Access Compliance Report Public Rights-of-Way (Curb Ramps)

Main Street: CADENCIA_ST		Cross Street: LIGADO_ST		Location:	W
ADA ID: RPRK211119120651	Ramp Type: Type 4 - Parallel	Initial Pass/Fail: Fail	Overall Compliance: No	Severity Score:	15
Codes/Mitigation Info/Possible Solution			Field Measurements/Component Compliance

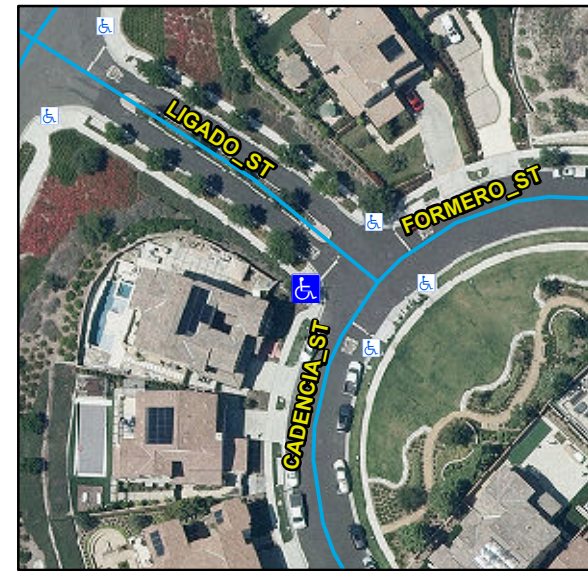
Compliance	Description	Data	Compliance	Description	Data
N/A	Ramp Length LT (in)	94	N/A	Ramp Length RT (in)	69
Yes	Ramp Width LT (in)	65	Yes	Ramp Width RT (in)	65
No	Ramp Run Slope LT (%)	11.9	Yes	Ramp Run Slope RT (%)	2.6
Yes	Ramp Cross Slope LT (%)	1.8	Yes	Ramp Cross Slope RT (%)	0.1
N/A	Landing Present	N/A	N/A	DWS Provided	N/A
N/A	Landing Length (in)	N/A	N/A	DWS Contrast	N/A
N/A	Landing Width (in)	N/A	N/A	DWS Length (in)	N/A
N/A	Landing Run Slope (%)	N/A	N/A	DWS Full Width	N/A
N/A	Landing Cross Slope (%)	N/A		DWS Offset Type	N/A
N/A	Landing Movement Obstructed?	N/A	N/A	DWS Offset Left (in)	N/A
	Landing Movement Type	N/A	N/A	DWS Offset Right (in)	N/A
N/A	Landing Shared	N/A			
N/A	Clear Space	Yes			
N/A	Clear Space To Crosswalk (in)	N/A			
N/A	Marked Crosswalk 1	No	N/A	Marked Crosswalk 2	No
	Crossing 1 Direction	SE		Crossing 2 Direction	NE
	Marked Crosswalk 1 Width (in)	N/A		Marked Crosswalk 2 Width (in)	N/A

Remove & Replace Curb Ramp With Two New Directional Ramps or Equivalent.

R304.3.2, STD 1115
